We would like to thank the referees for taking the time to carefully review our manuscript and for providing valuable comments and suggestions. We have made the necessary changes to improve the paper and our responses to their comments are provided below.

## RC1

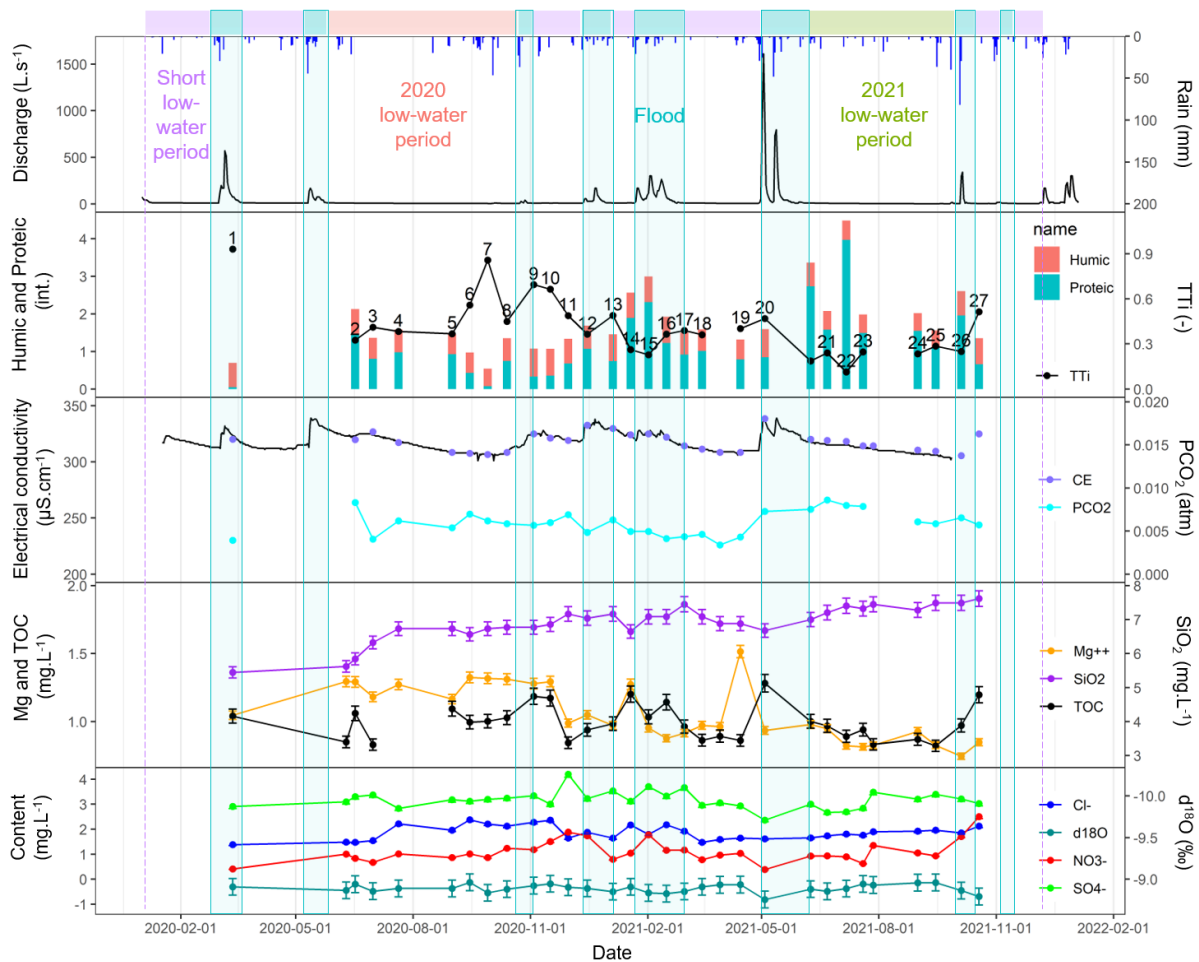
**3) Double-check the positive correlation between electrical conductivity (CE) and spring discharge, which is very unusual compared to other karst springs.**

RC1- Figure 4 - **CE should positively correlate with Mg<sup>2+</sup> and SO<sub>4</sub><sup>2-</sup> but Fig. 4 shows opposite correlation. Please double-check the time of the data. The CE has the second lowest CoV of 3% in Table 2 and the range of CE in Fig. 4 is approximately from 310 to 340 for point data and 285 to 340 for the continuous line. There are some discrepancies between Table 2 and Figure 4.**

Correlation between electrical conductivity and discharge is still 0.42 after check, as it appears in Fig. 5(a). Visual assessment of the time series in Fig. 4 is consistent with this positive correlation as important peaks of electrical conductivity are observed during flood events.

The following explanation was added to the section 3.2.1 Hydrodynamic and hydrochemical functioning of Millet spring, and  $pCO_2$  was added to Fig. 4:

Figure 4 was checked and no trouble was identified. Mg is not correlated with electrical conductivity, as shown in Fig. 5(a).

CE data from Table 2 was calculated based on point (field) data to be consistent with other data, this is why it doesn't perfectly match the line (automated in-situ monitoring) data.

The beginning of the curve is out of the selected time range. Its goal was to show the context. It appears that an unexplained gap of 31 μS/cm was identified on the curve. It is probably due to a problem with the prob. To provide only accurate data, the beginning of the curve was removed in Figure 4.

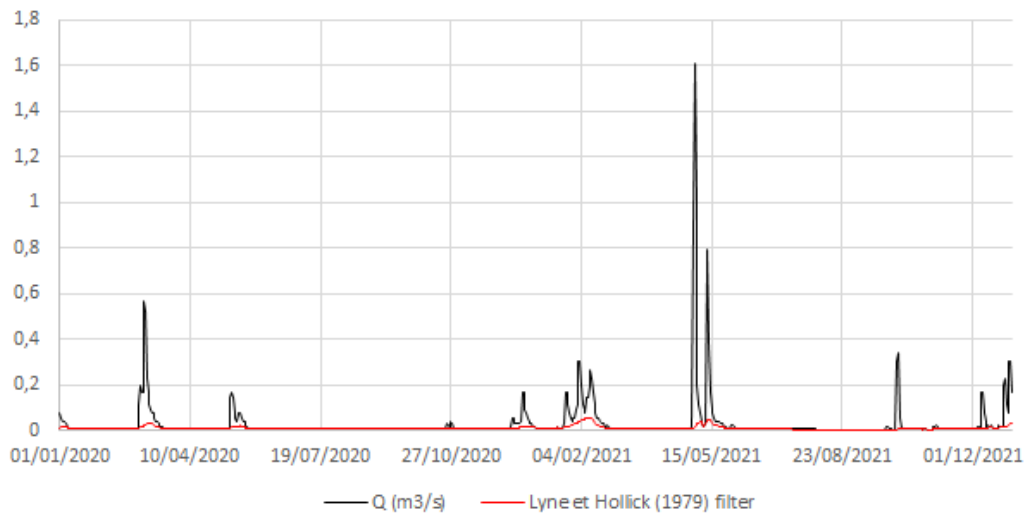
**2) Perform hydrograph separation to quantify the storm flow and base flow for the storm events in different seasons, because this information is also helpful to interpret the TTI results.**

Shape of the hydrograph suggests fast reactivity and thus fast circulations within the hydrosystem which is confirmed by hydrograph separation (see below).

However flash flow to baseflow separation based on hydrograph can not be directly related to TTI as they inform about pressure transfer while TTI mainly bears information about mass transfer. Moreover, this separation does not allow to determine whether fast water is coming from fast infiltration or if it was stored and mobilized thanks to the reconnection with the karstic network.

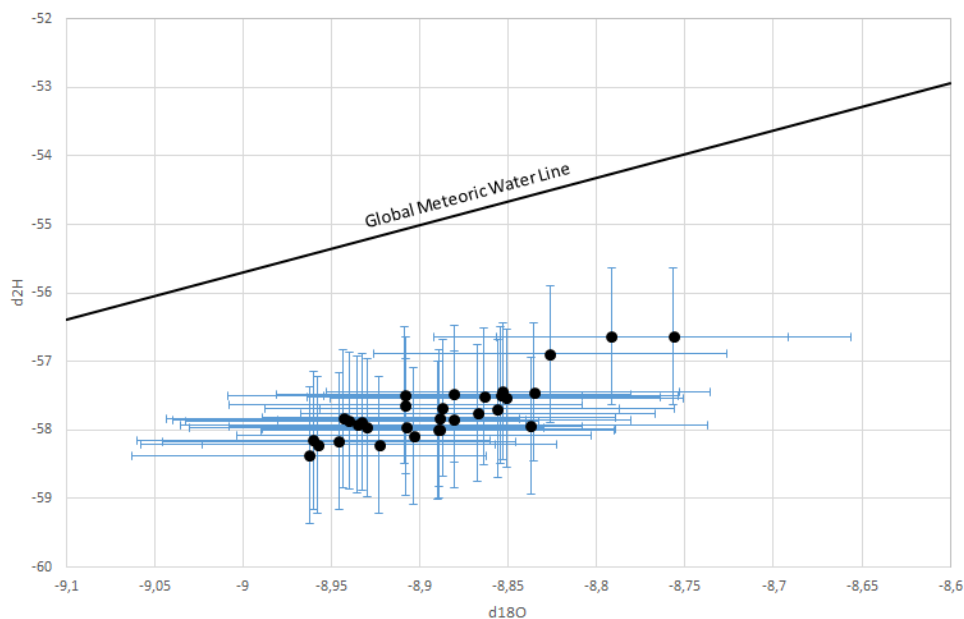
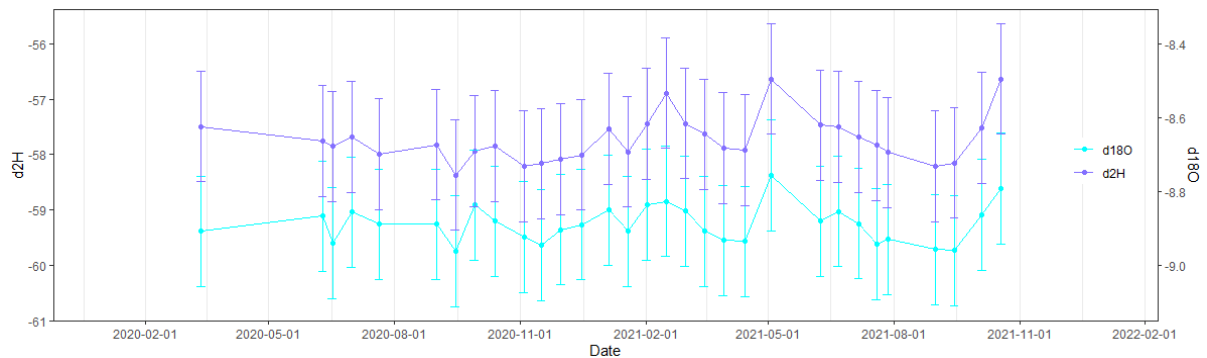
**RC1- Line 164 - It is suggested making a comparison of delta O-18 between the spring water and local precipitation. It is also suggested including deuterium data if possible.**

Deuterium was analyzed but deuterium and delta O-18 time series are similar, both are very stable with variations within the uncertainty range (see first figure below). We chose to show <sup>18</sup>O only to limit redundancy.

d18O versus d2H graph (see second figure below) illustrates the absence of evaporation process. Our data lies far from the global meteoric water line but seems to have the same tendency, probably corresponding to the local meteoric water line. No isotopic data from local precipitation is available.

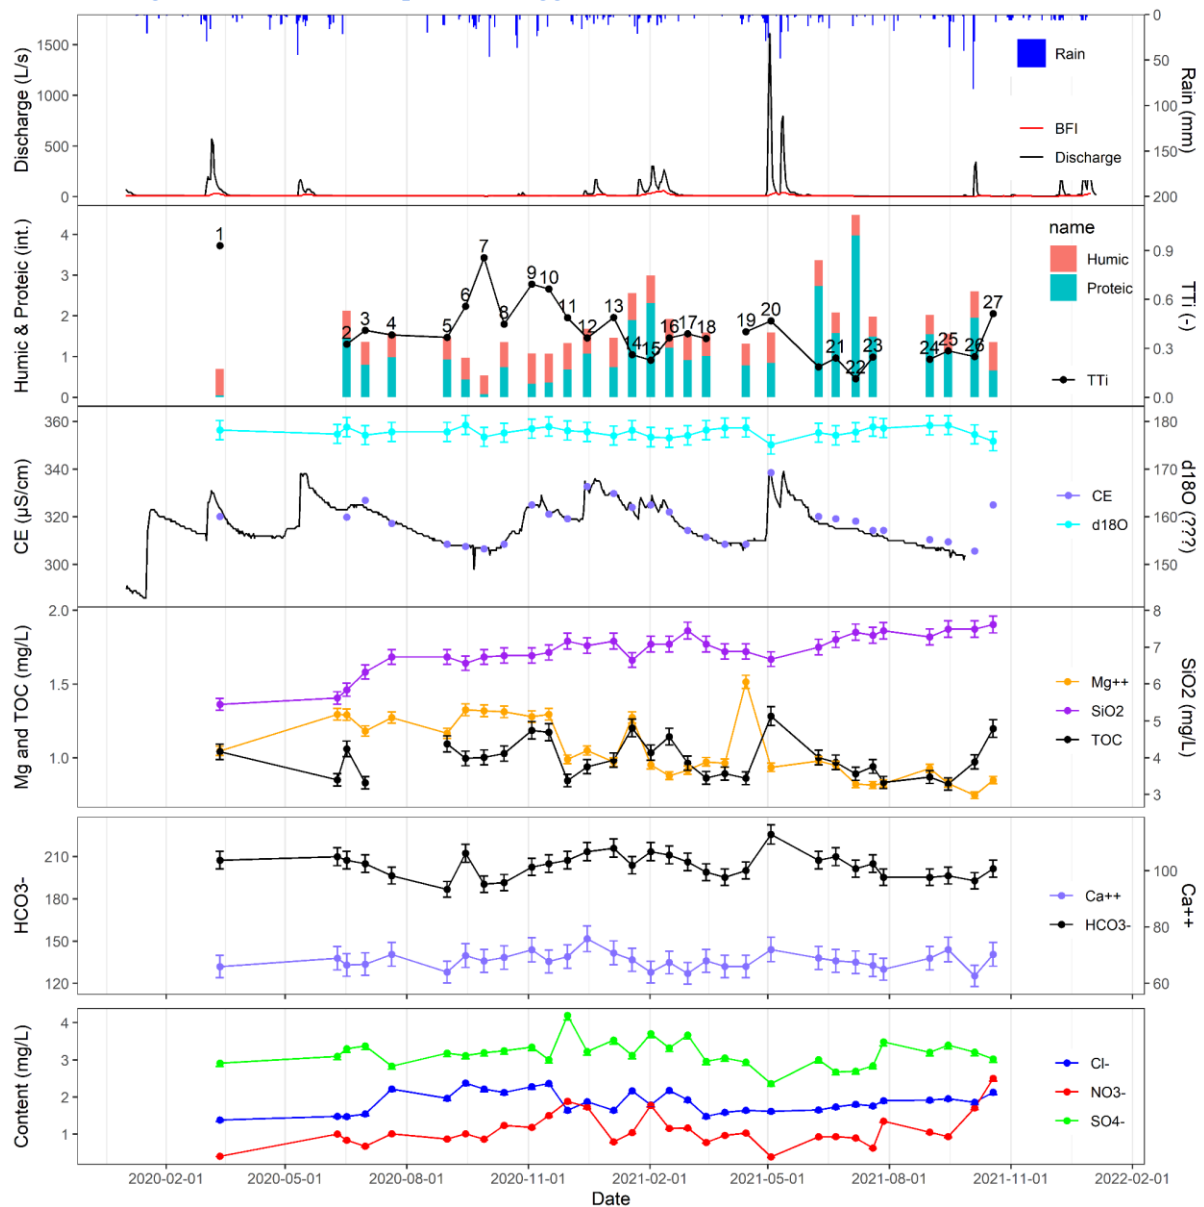
**RC1- Line 170 -  $\text{Ca}^{2+}$  and  $\text{HCO}_3^-$  of karst aquifer groundwater are generally from aquifer rocks- limestone and dolomite. The recharge water from precipitation generally has much lower  $\text{Ca}^{2+}$ . However, the precipitation passing thick vadose zone or unsaturated zone may have elevated  $\text{Ca}^{2+}$ . It is unlikely the case here because the fast response discharge to precipitation was observed.**

As seen in the graph below,  $\text{Ca}^{2+}$  and  $\text{HCO}_3^-$  vary almost exactly like electrical conductivity. The link with discharge is answered in the previous suggestion 3).

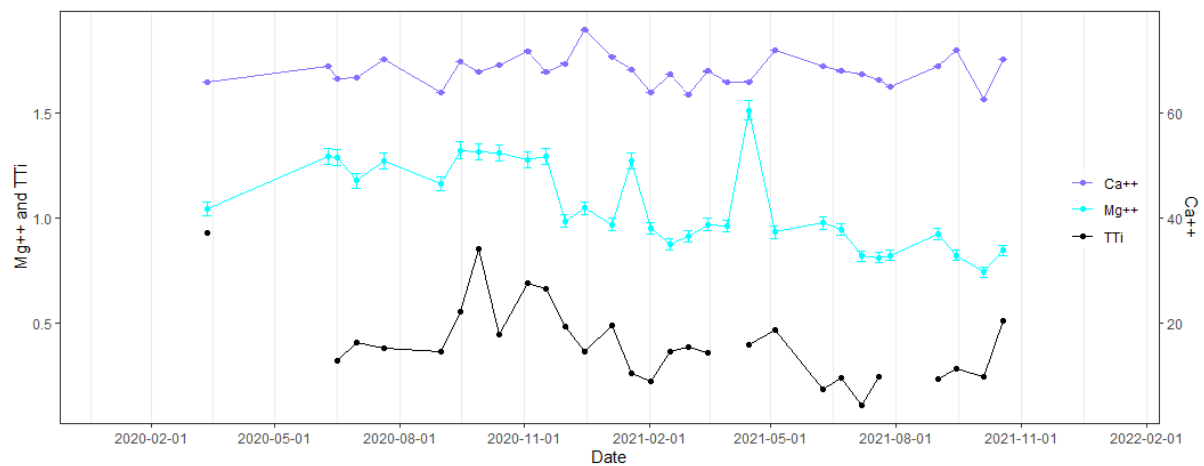
RC1 - Line 267 - **Dreiss (1989) presented a study to quantify the storm-derived water in the spring flow hydrographs with Ca<sup>2+</sup> and Mg<sup>2+</sup>, so these natural tracers could be additional evidence to TTI.**

Thank you for this comment/suggestion. As seen in the following graph, correlation between Ca<sup>2+</sup> and Mg<sup>2+</sup> is quite low for this spring.

- The Relationship between Mg<sup>2+</sup> and TTI is already discussed in the paper.
- Range of Ca<sup>2+</sup> variations is low so this element provides limited additional information about the spring's dynamics, this is the reason why it wasn't considered in the paper.

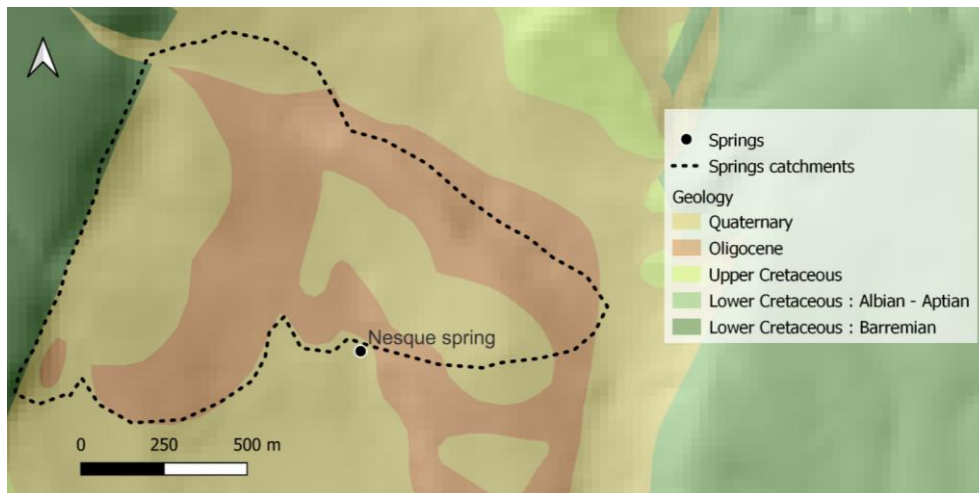
RC1- Line 282 - **The catchment of this spring in Fig. 1 is covered by the alluvial deposits but the authors didn't provide whether the source of this spring is from carbonate aquifer or alluvial aquifer. It is also not clear how the catchment was delineated. It looks that the upper gradient area of this catchment is not different from other spring catchments. Because the karstification or quick conduit is a key to explain the TTI, more information about this spring catchment should be provided.**

It is true that Nesque catchment seems to be covered by the Quaternary in Fig. 1. But Oligocene deposits are actually also widely outcropping, as seen in the map zoom below. Furthermore Quaternary deposits are thin and the aquifer is developed within Oligocene deposits, as mentioned in Table 1. Oligocene carbonates are different from Cretaceous carbonates from other spring catchments : they correspond to lake deposits, are more marneous, and the karstification is less developed.

Karstification-related information is provided in Table 1.

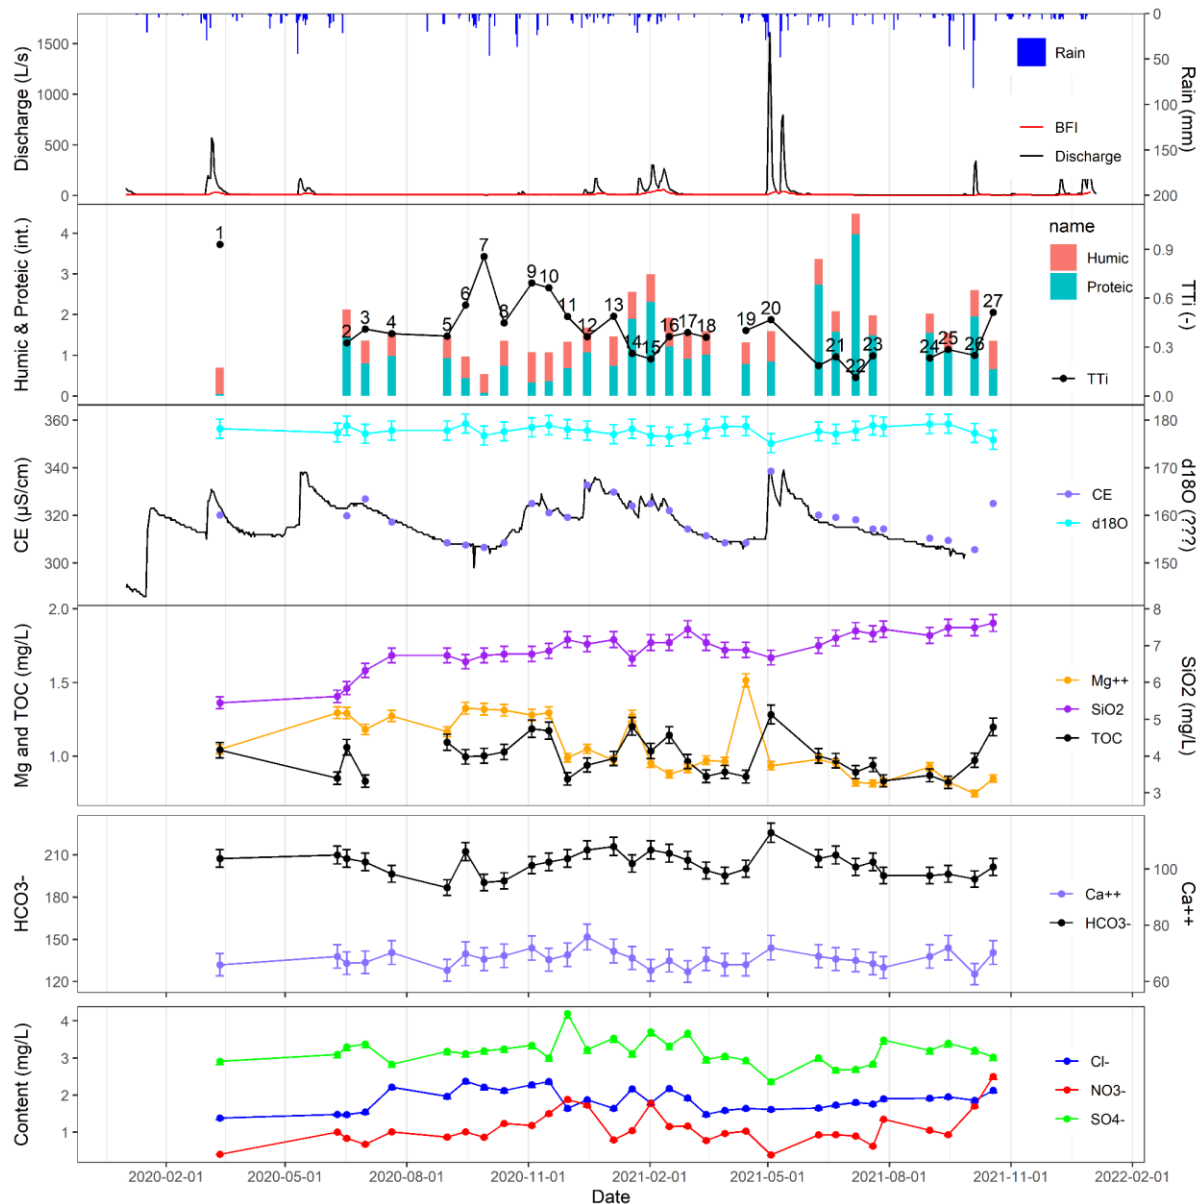
**3) Since this is a karst system, how about the time series of typical species such as Ca and HCO<sub>3</sub> look like? And how they are correlated with the principal components of PCA? I don't understand why the authors chose SiO<sub>2</sub>, Cl, and NO<sub>3</sub> as the representative species here. Please also clarify.**

Time series of typical species such as Ca<sup>2+</sup> and HCO<sub>3</sub><sup>-</sup> are reported in the graphs below. They vary with the same shape, and are very well represented by electrical conductivity. To omit redundancy, we made the choice to represent only electrical conductivity. Please refer to our answer to the comment of line 171 of RC1 and suggestion 3).

For the same reason, these two elements were omitted in PCA to avoid imbalance of the result. As electrical conductivity is mainly represented by Ca<sup>2+</sup> and HCO<sub>3</sub><sup>-</sup>, these 3 parameters provide almost the same information which is susceptible to imbalance PCA and do not provide representative results.

SiO<sub>2</sub>, Cl<sup>-</sup>, NO<sub>3</sub><sup>-</sup> and other parameters like Mg<sup>2+</sup> were selected for their ability to distinguish flows and springs of the system Fontaine de Vaucluse in previous studies (Barbel-Périneau, 2013; Blondel, 2008; Garry, 2007).
